# Agenda item 11

2025/0047/PAC  
(ECU00005038)

NatureScot comments

**ELECTRICITY ACT 1989  
THE ELECTRICITY WORKS (ENVIRONMENTAL IMPACT ASSESSMENT) (SCOTLAND) REGULATIONS 2017  
APPLICATION FOR SECTION 36 CONSENT FOR CLUNE WIND FARM**

### Annex 3: Map showing crucial areas of the Slochd GCR site

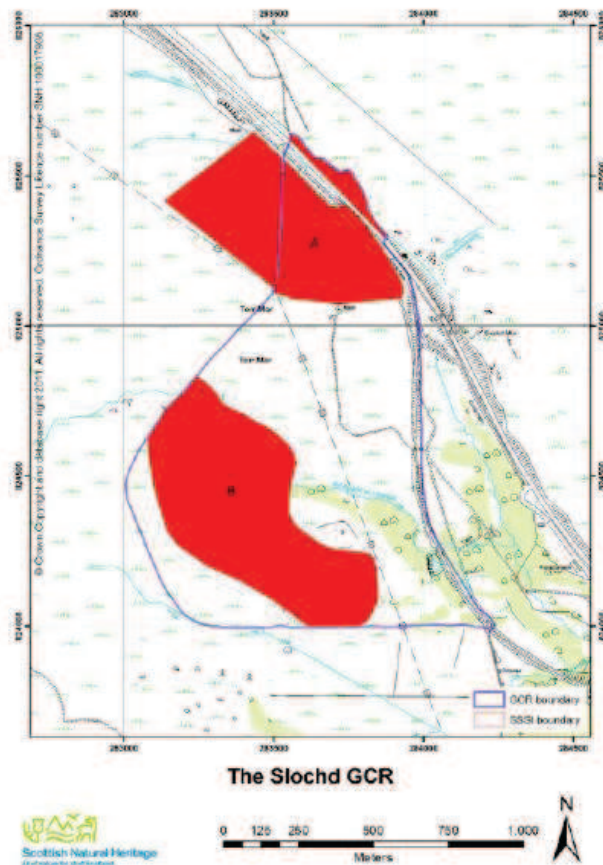
Although the proposed wind farm itself will not affect this site, the EIAR has not assessed potential impacts from the Outline Habitat Management and Biodiversity Enhancement Plan which includes proposals for woodland expansion within the GCR site. This could obscure the “rock outcrops” which the GCR site is important for. Should woodland expansion be proposed within the Slochd GCR site we recommend that the final Habitat Management and Biodiversity Enhancement Plan includes the following mitigation:

- **Should the wind farm be consented, any proposals for woodland expansion within The Slochd GCR site should follow the mitigation and management measures outlined in NatureScot’s *Geological Conservation Review Sites – Forestry and Woodland Standing Advice and Guidance*<sup>4</sup>.**

Sections 2.1.1 and 2.1.2 of the above guidance describes the mitigation and management measures that would be required to ensure that planting and natural regeneration does not affect the nationally important geological features of the site. These refer to the “crucial” and “context” areas of the GCR site. A map of these areas is provided in Annex 3 to this letter.
